Change Notice Information Announcement

GREEN Change Notice

Product Name(s): Magnecraft 92

Product Line Description: Power Relay

Product Photos

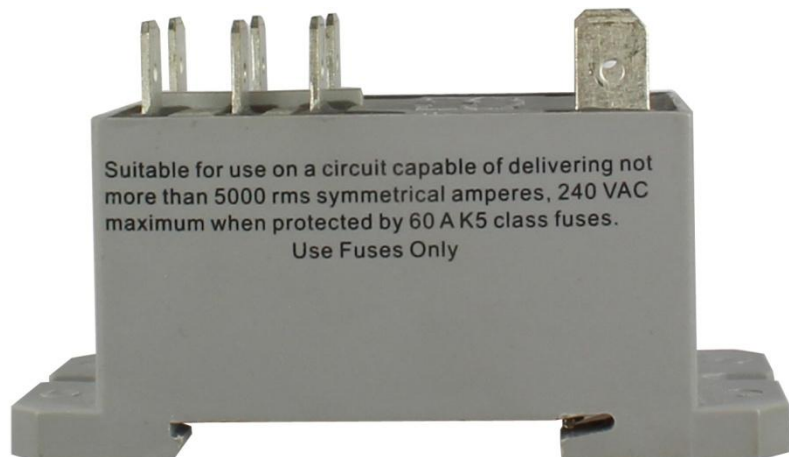
1. Product Color Change:

FROM: Light Grey Pantone 427C TO: Black Slate RAL7016

2. Minor Terminal Dimension Change:

FROM: Max Height from 38mm TO: 39.05 mm
